3.6 EXTERNAL STAIR & CORE ROTATION

3.7 LEVEL 5

Figure 3.5.1_The external stair has been redesigned to extend to the first level of the library.

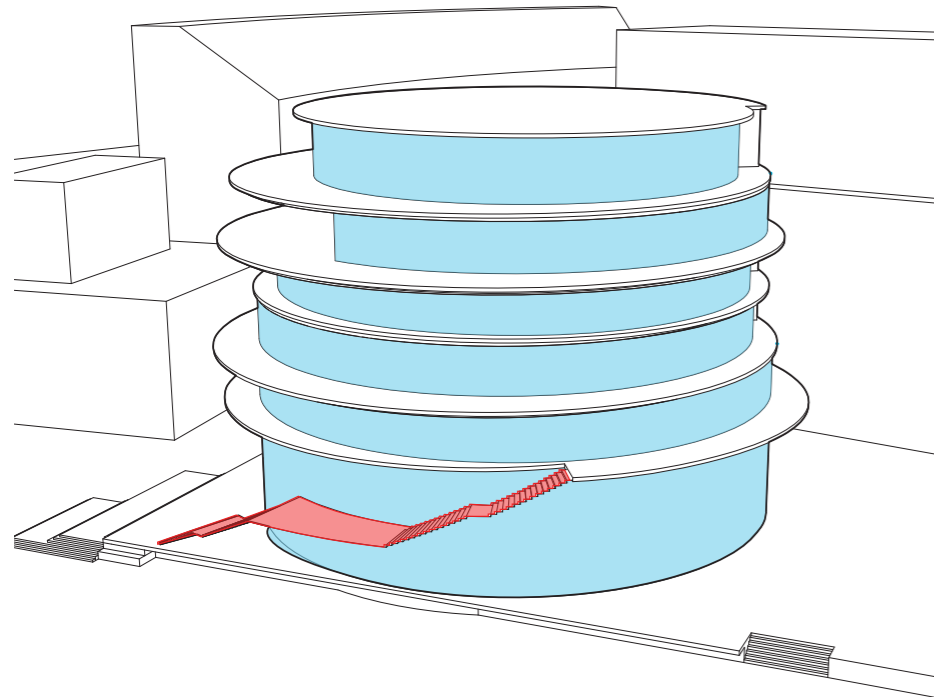
The external stair lodged within the Development Application extended to the mezzanine level only and was 3m wide at the base.

At the request of the City of Sydney (the library tenant), the external stair has been redesigned to extend to the first level of the library and widened slightly at the base to 3.2m wide. It has been carefully considered so as to not reduce the floor area of the Library.

This request was made to ensure a civic and public address is provided to the library with access previously via the lifts only. The flaring out of the stair at the base addresses The Boulevard, the primary pedestrian link to Darling Harbour and the foreshore.

Figure 3.5.3_The core is rotated 22.5 degrees from original position to the south

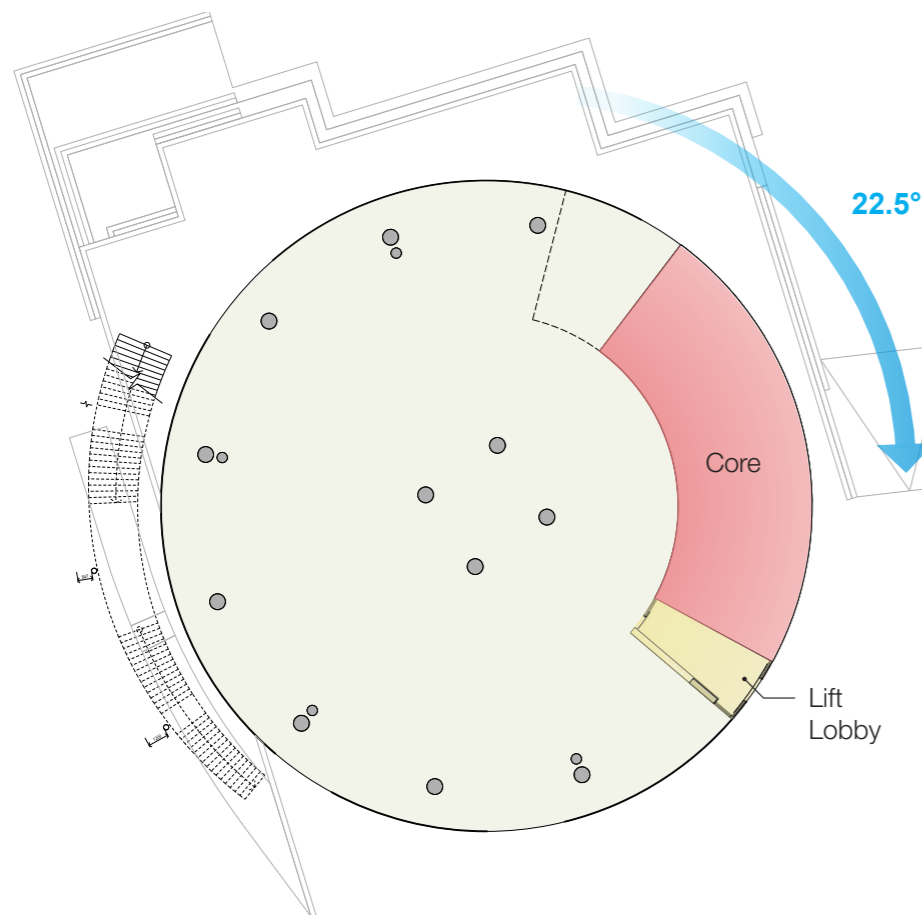
In discussions with the City of Sydney regarding a greater lobby presence facing The Square the location of the core has been adjusted.

The core has been rotated/pivoted 22.5 degrees in a clockwise direction to improve how the building is perceived from a number of key vantage points including:

1. Little Pier St/Factory Lane: A more active facade is now apparent from Little Pier St/Factory Lane. Refer to Figure 3.5.4 and 3.5.5.
2. The Square: A more prominent/visible lobby entry has been created from The Square. Refer to Figure 3.5.3.

Figure 4.5.2_Proposed Level 5 Bar/Restaurant plan (with indicative fit out)

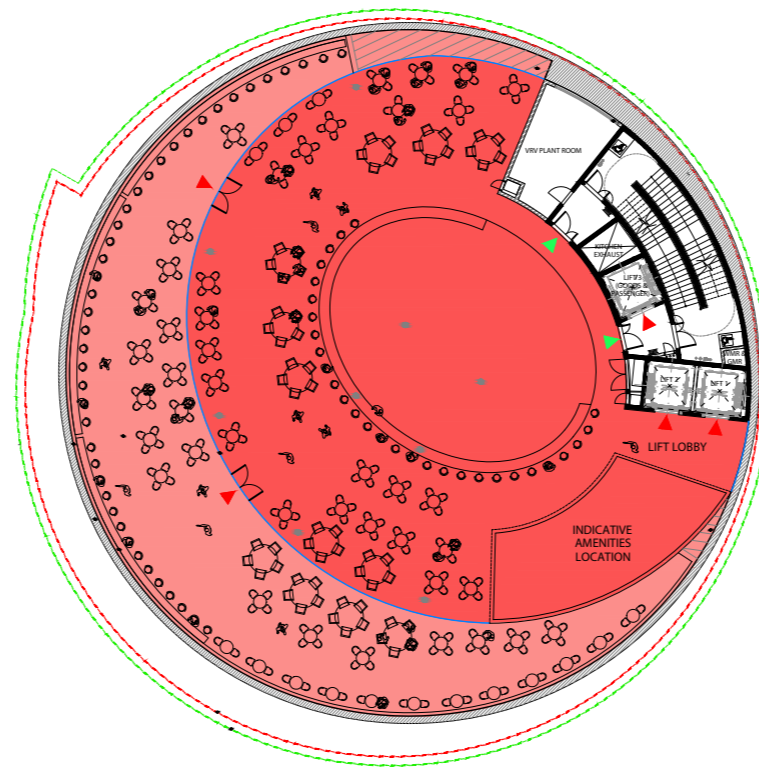
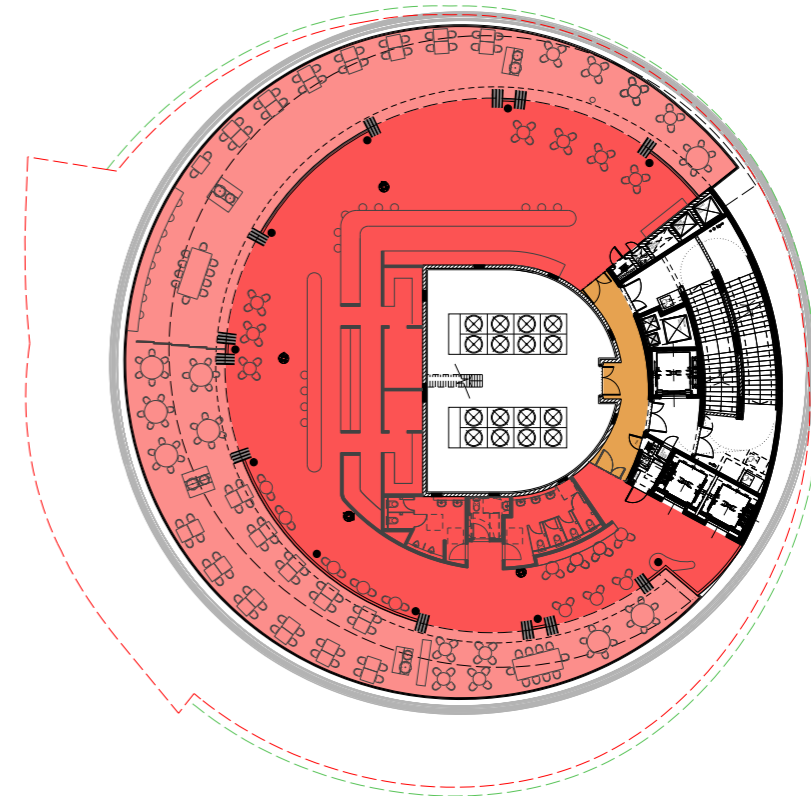
“..... The BCA Report lodged indicates the roof level restaurant and bar could be occupied by up to 689 patrons and the child care centre, with 90 spaces, would be operating until 7.00pm.”

It is noted that the proposal includes a rooftop restaurant and bar in addition to community facilities and markets. This appears to be inconsistent with the original purpose of the building on the North Plot and inappropriate to the location given

A reconsideration of the patron numbers for Level 5 has been undertaken having regard to:

- Centralised plant relocation to Level 5.
- Lifting rearrangements.

Level 5 has been replanned to accommodate a revised mechanical servicing strategy. The DA lodged provided mechanical plant rooms at each level of the building with louvres to the façade. A more efficient strategy has since been developed which replaces the level by level plant with a single open air plant room. This plant room is centrally located on Level 5.

- Reduced patron numbers of Level 5.
- Reducing the extent of louvres to the façade and therefore improving the façade of the building.
- A more sustainable design outcome assisting with Green Star targets.
- A better operational system for tenants.
- Improved lifting waiting times.

Figure 4.2.1_Proposed Ground Floor Plan - Indicative Market Hall Fit Out

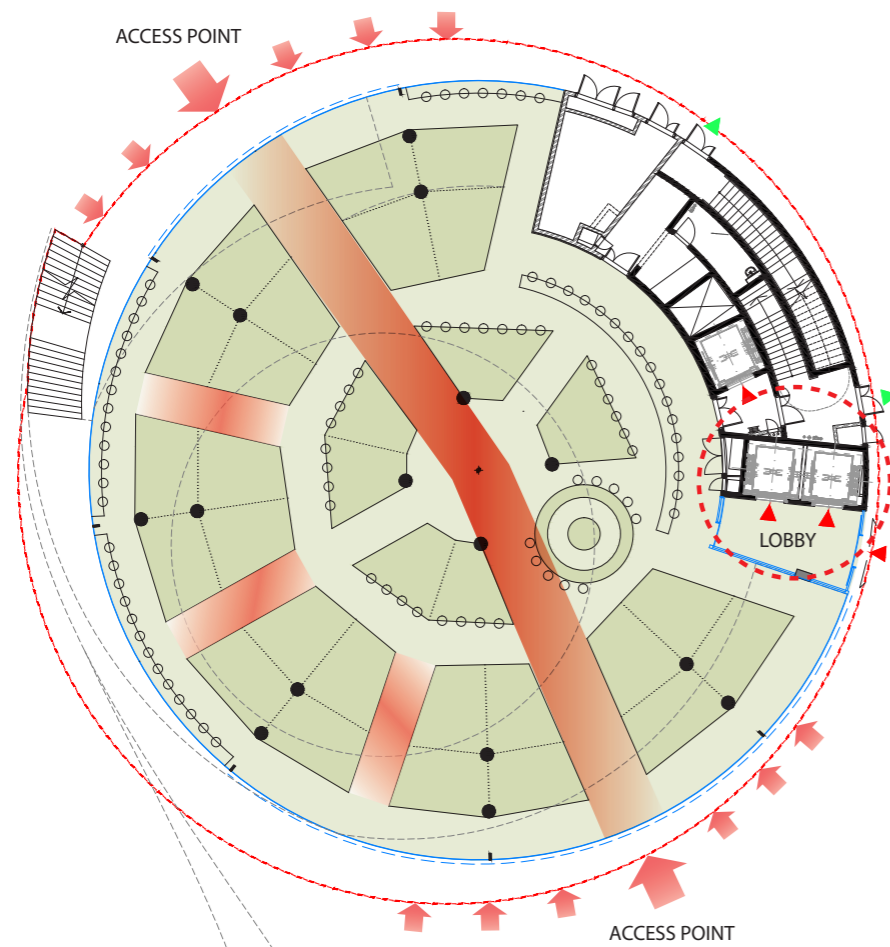
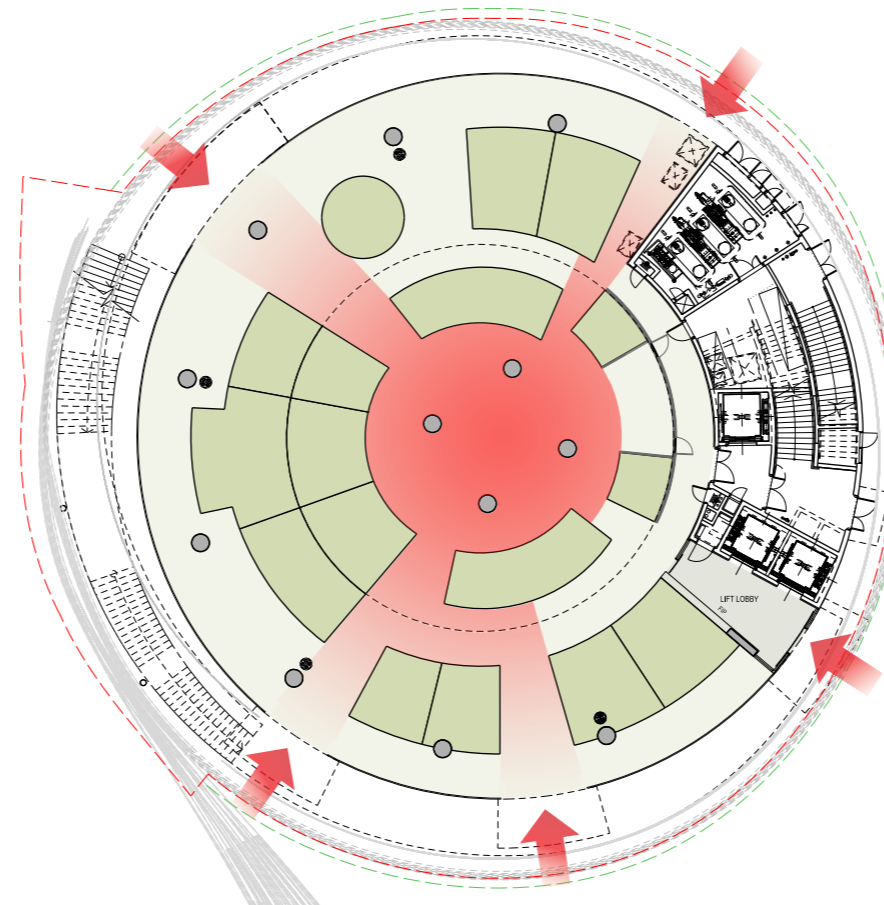
The layout of the market hall has developed since the DA that was submitted in March 2016. There has been a reduction of the number of tenancies from 32 tenancies to 18 tenancies to respond to loading and traffic requirements. The access spine has been maintained from the north to the south and has shifted with the rotation of the core.

The main entry to the north has shifted to align with the landing of the external stair and public domain terraces. As a result of the benefit of rotating the core a secondary entry has been created to the north west to capture people walking from Little Pier St.

To the south an entry has been created at the top of the public domain ramp to capture people at this node which reinforces pedestrian connectivity.

Figure 4.4.2_Proposed Mezzanine (with indicative fit out)

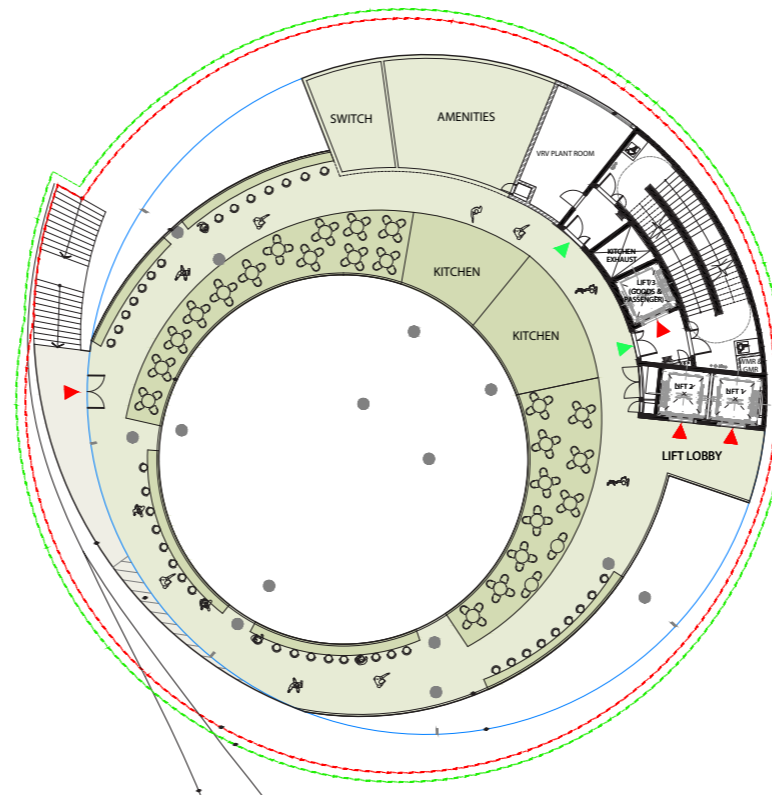
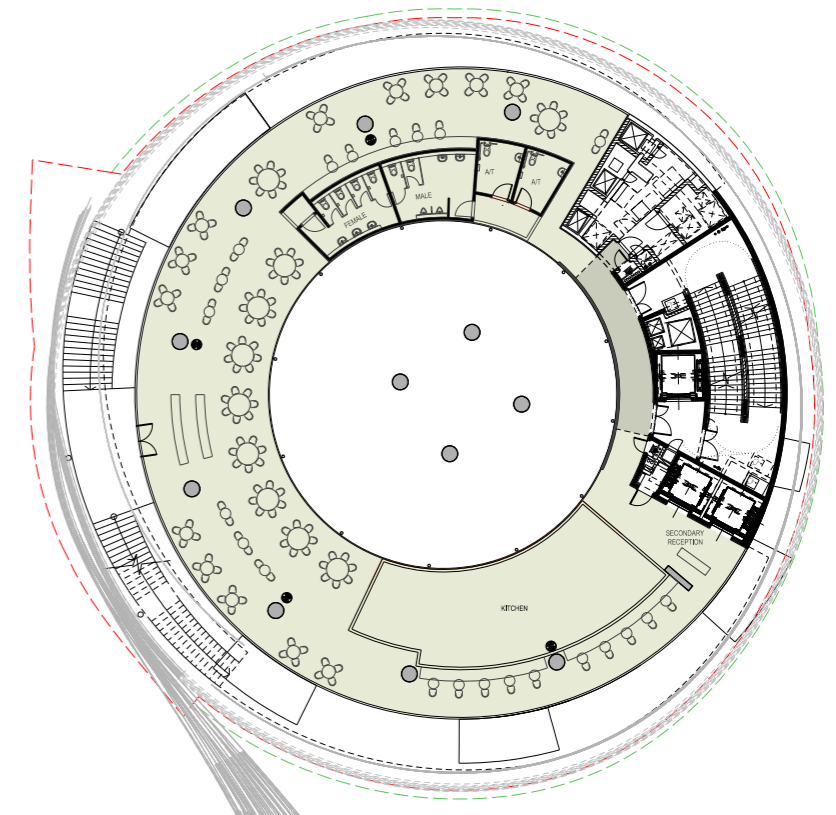
Since the lodgment of the DA, the Mezzanine level has been replanned to improve the future functional layout to the food and beverage offering. The three separate voids have been consolidated into one central atria which not only enhances the Mezzanine design but also improves the relationship to the Ground Floor Market Hall.
